**LEVY NUCLEAR PLANT, UNITS 1 AND 2
DOCKET NOS. 52-029 AND 52-030
RESPONSE TO REQUEST FOR ADDITIONAL INFORMATION LETTER NO. 095 RELATED TO
PROBABLE MAXIMUM SURGE AND SEICHE FLOODING**

**Levy Nuclear Plant Units 1 and 2
Response to NRC Request for Additional Information Letter No. 095 Related to
SRP Section 2.4.5 for the Combined License Application, dated October 4, 2010**

NRC RAI NUMBER: 02.04.05-10

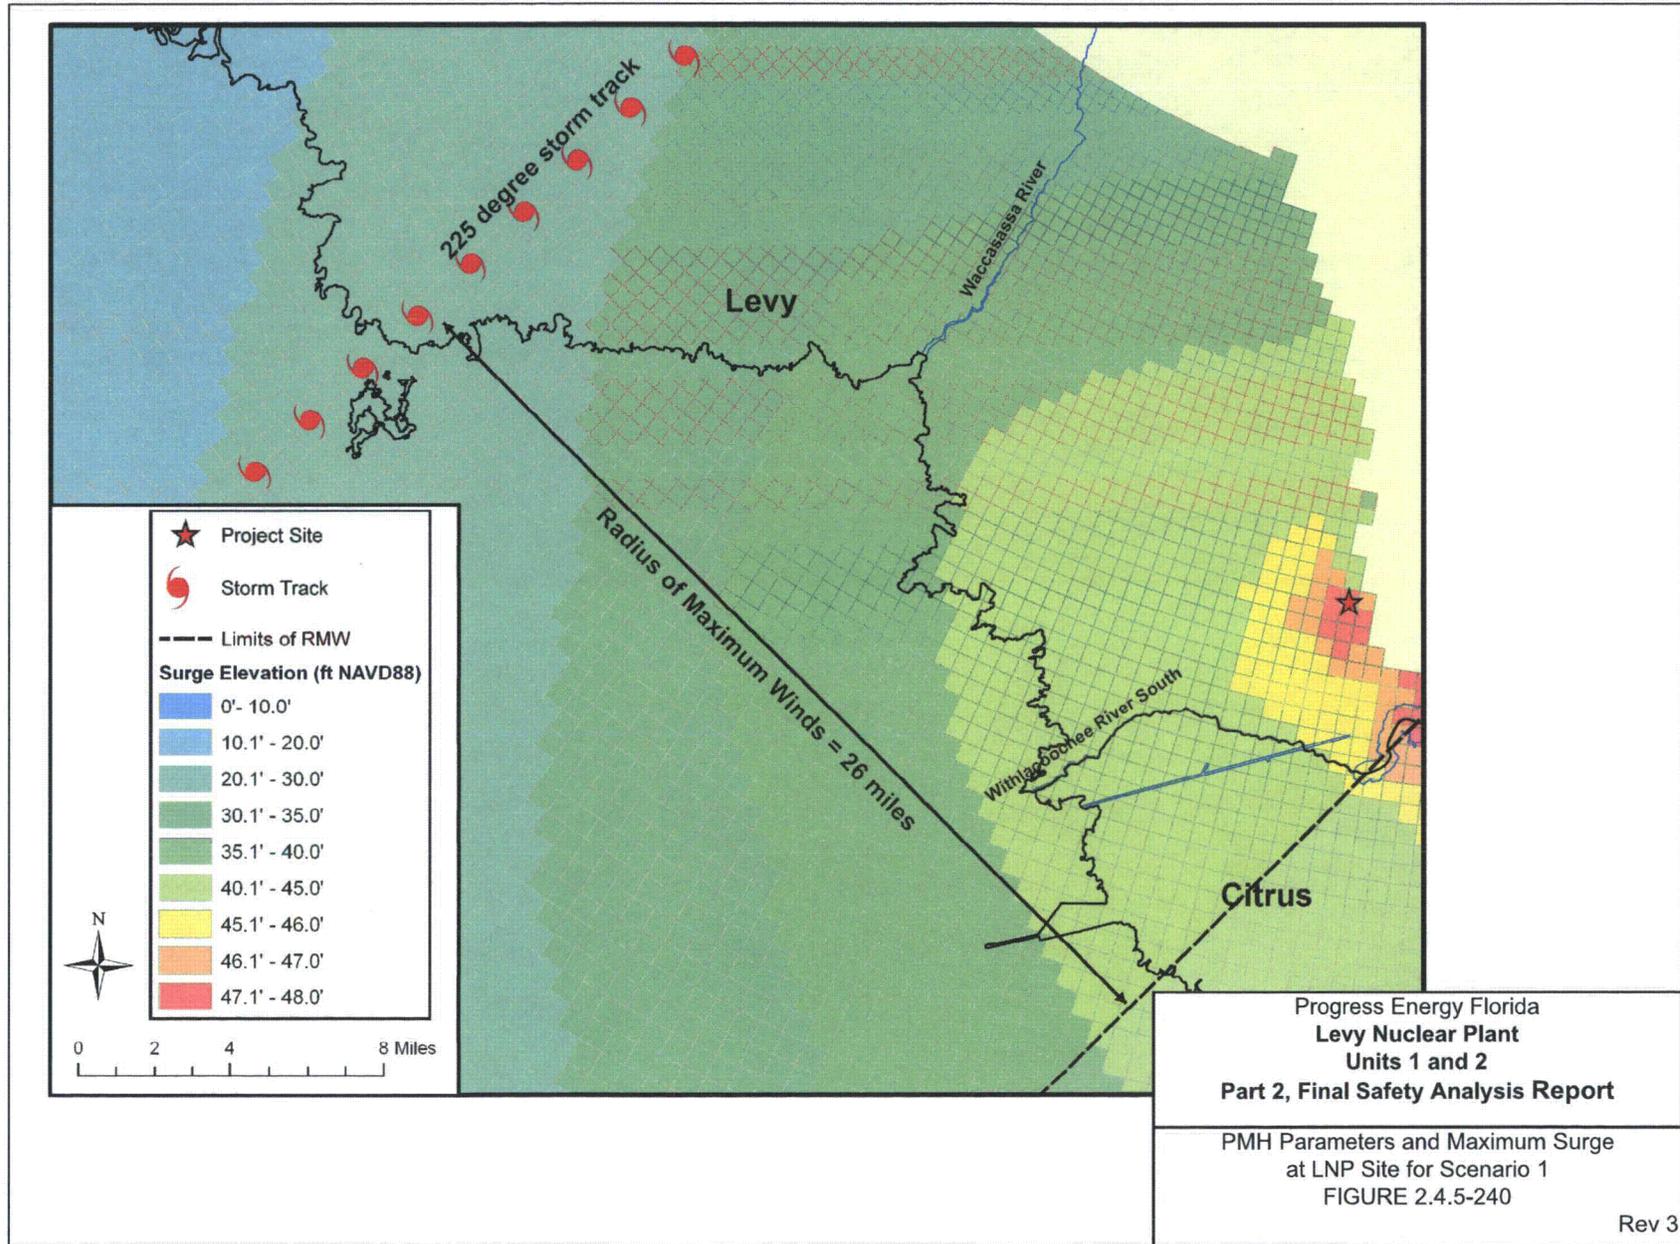
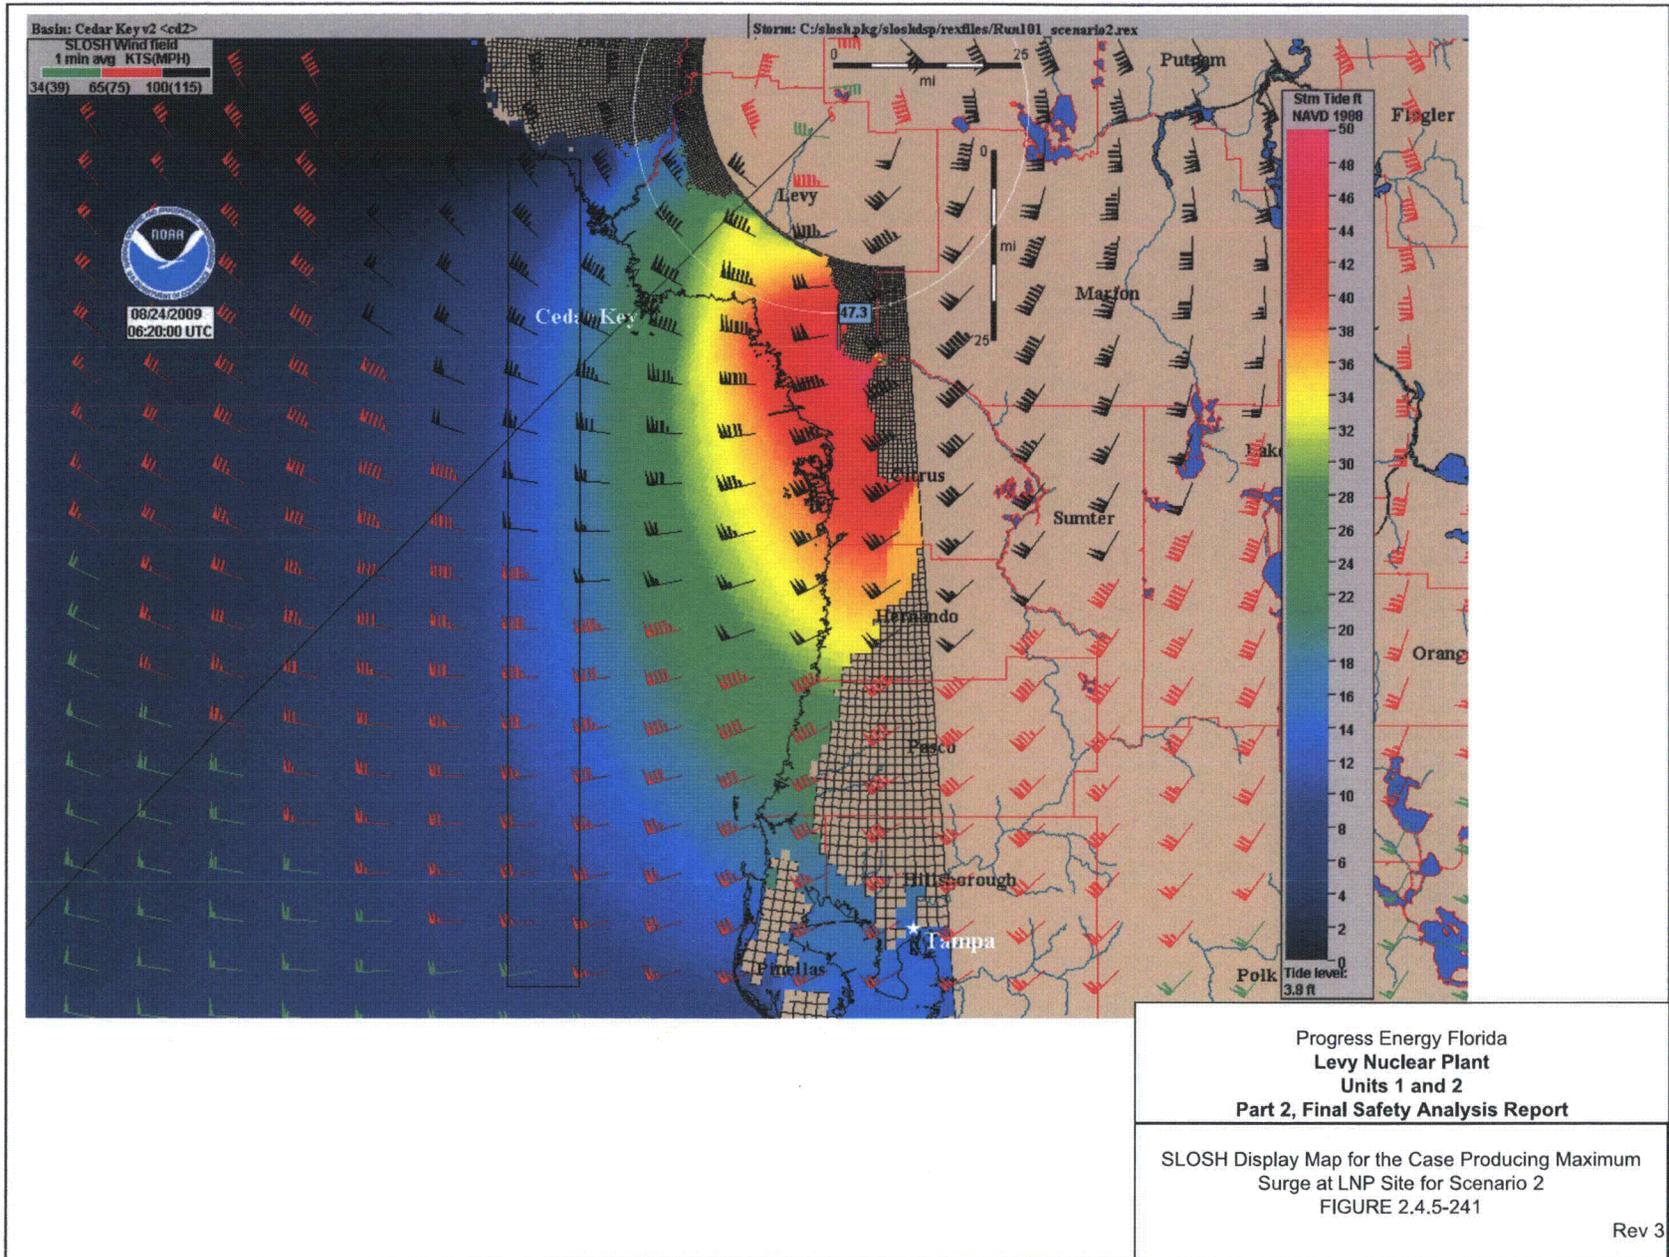
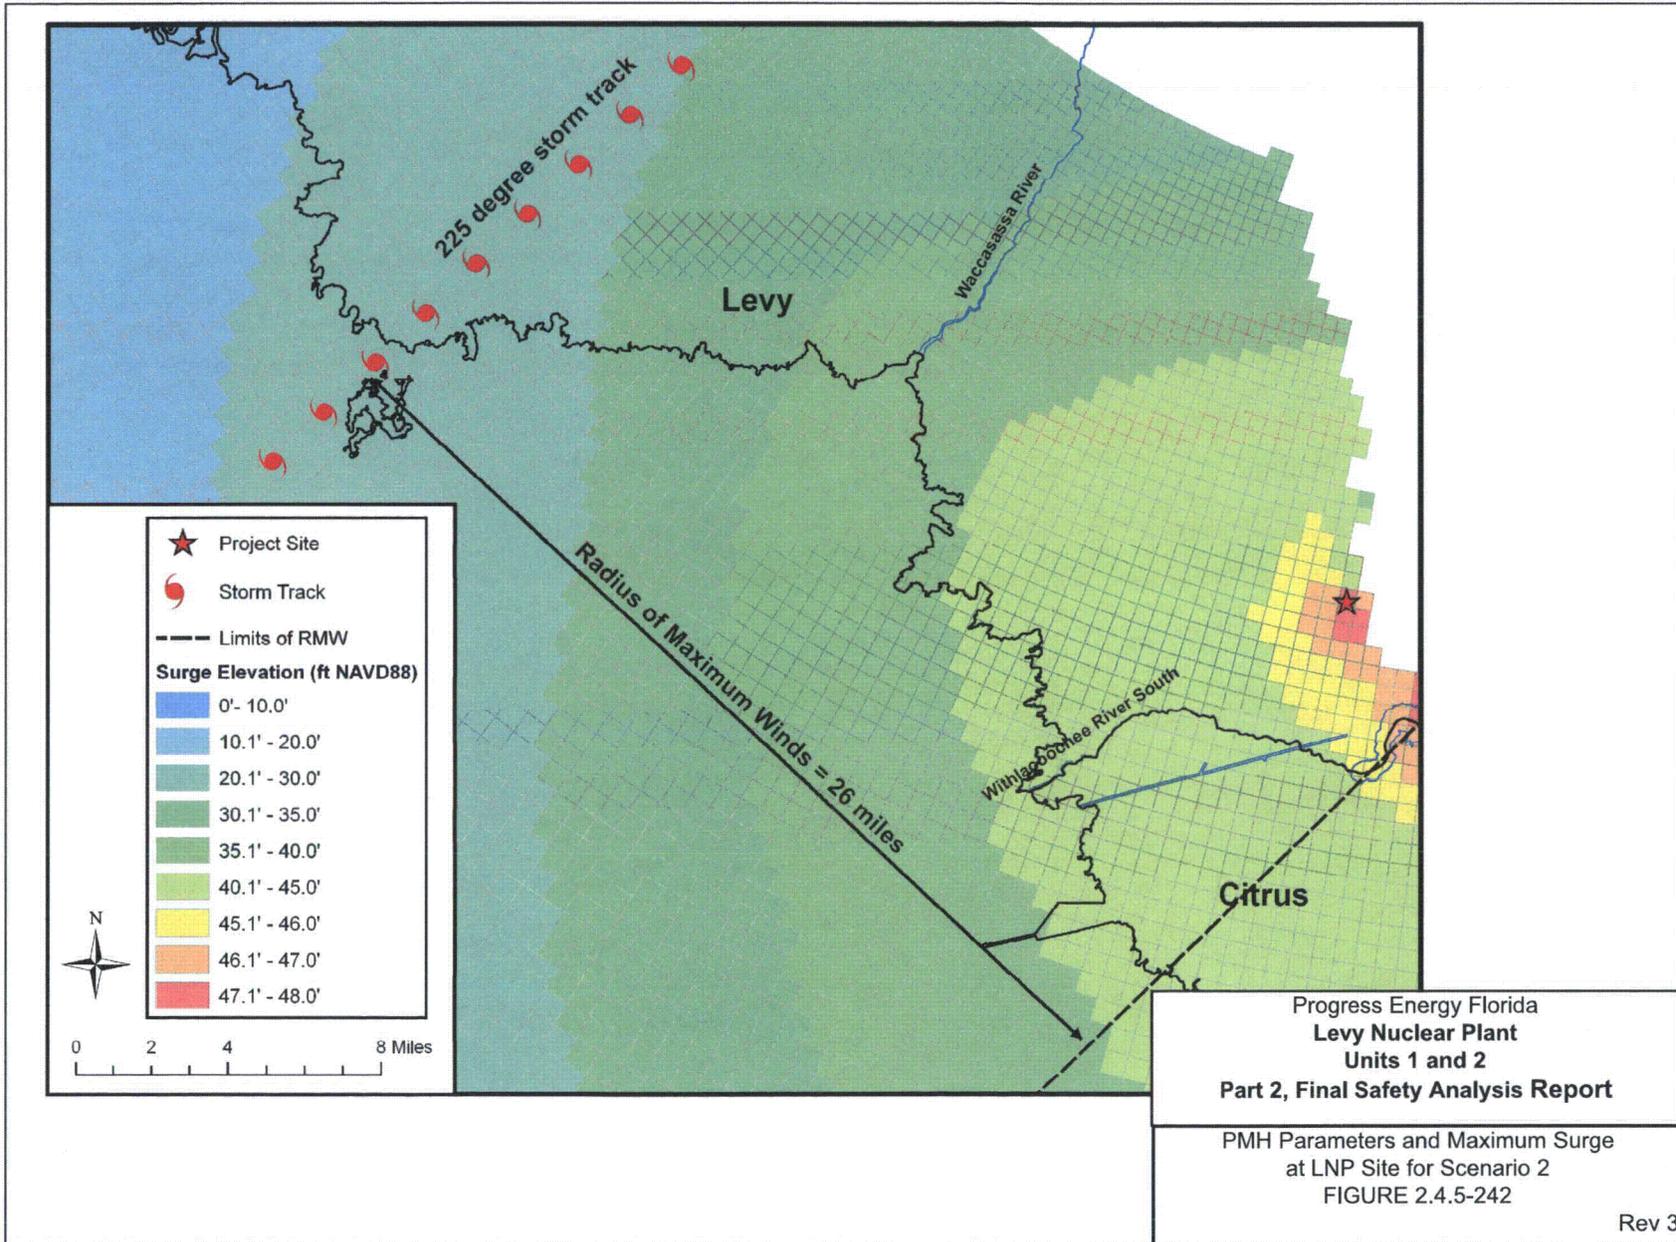
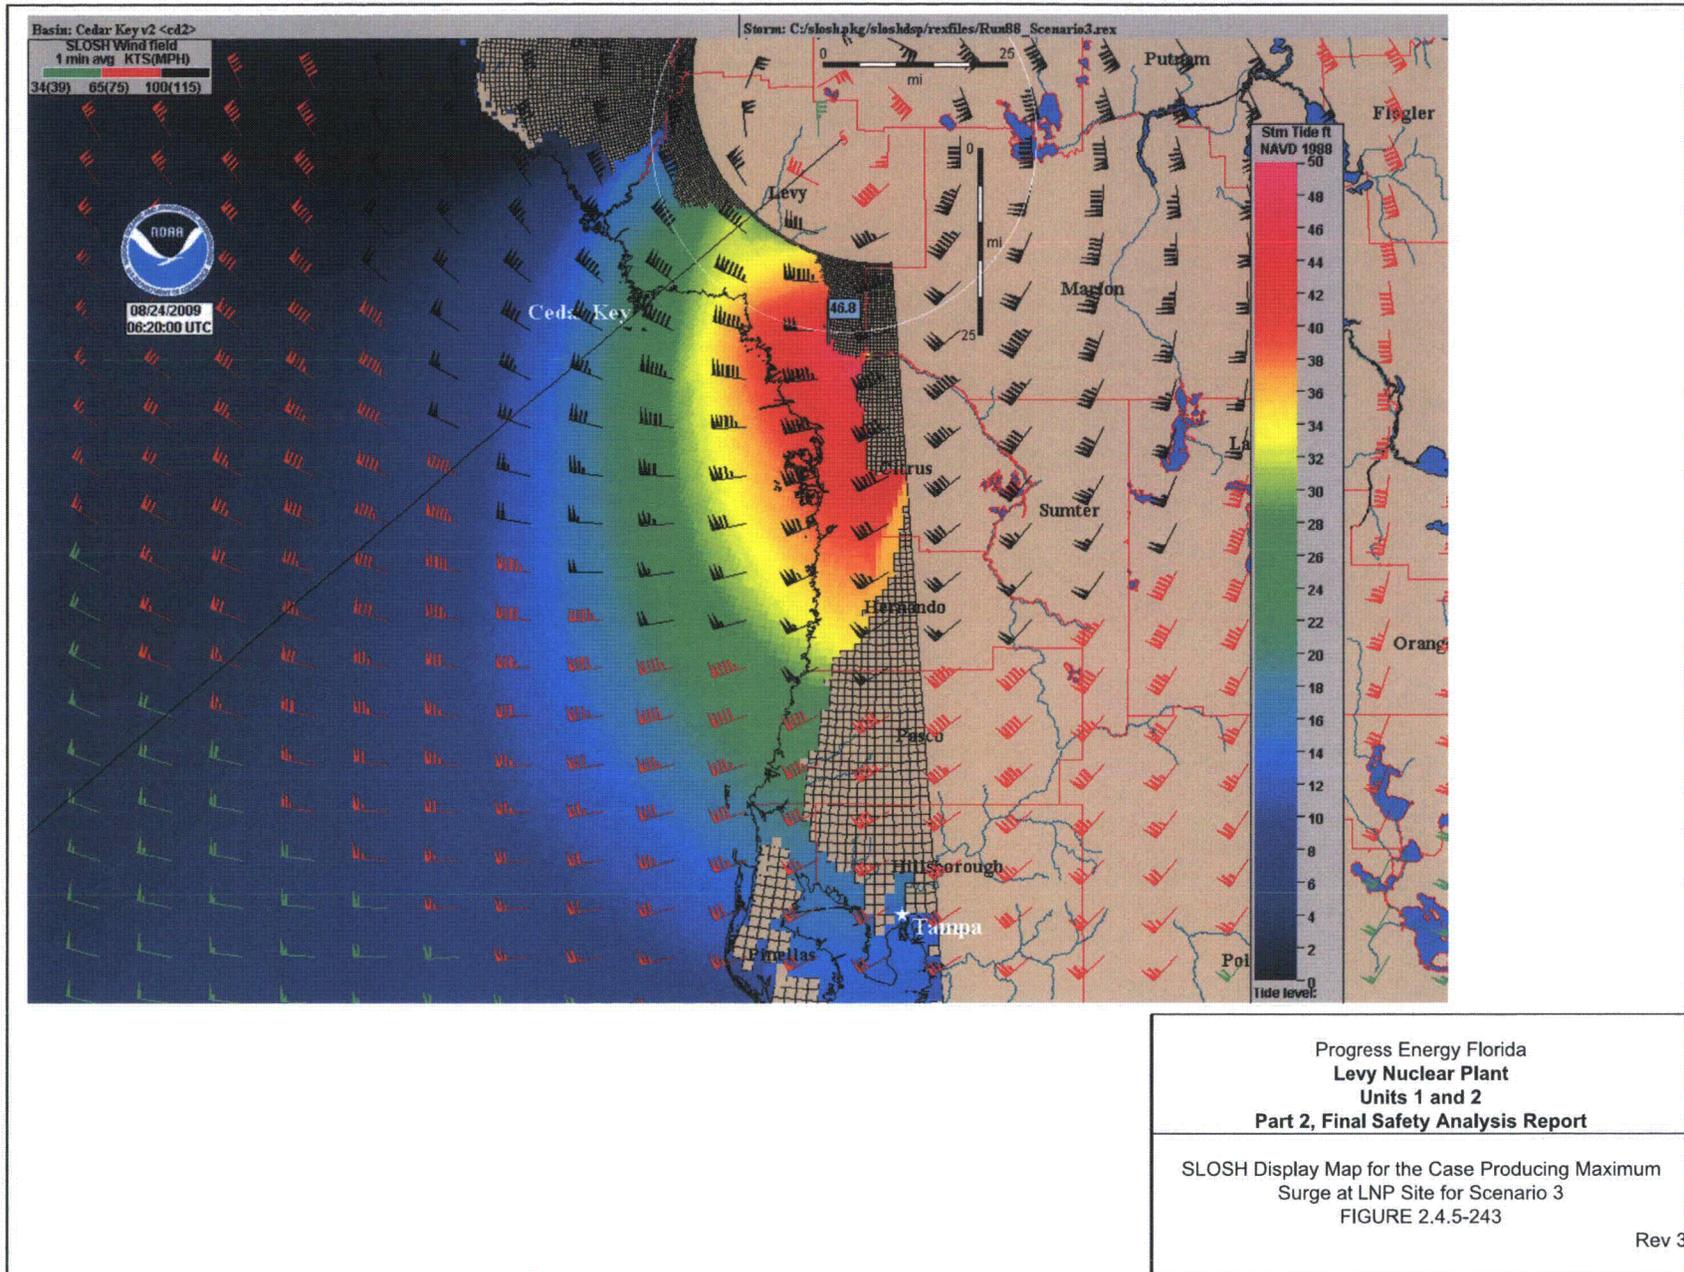
Figures RAI 2.4.5-10-6 through RAI 2.4.5-10-11 provide the SLOSH display screenshots and maps displaying the surge at the time of the peak surge for the site, for Scenarios 1, 2, and 3, shown in Table 7.
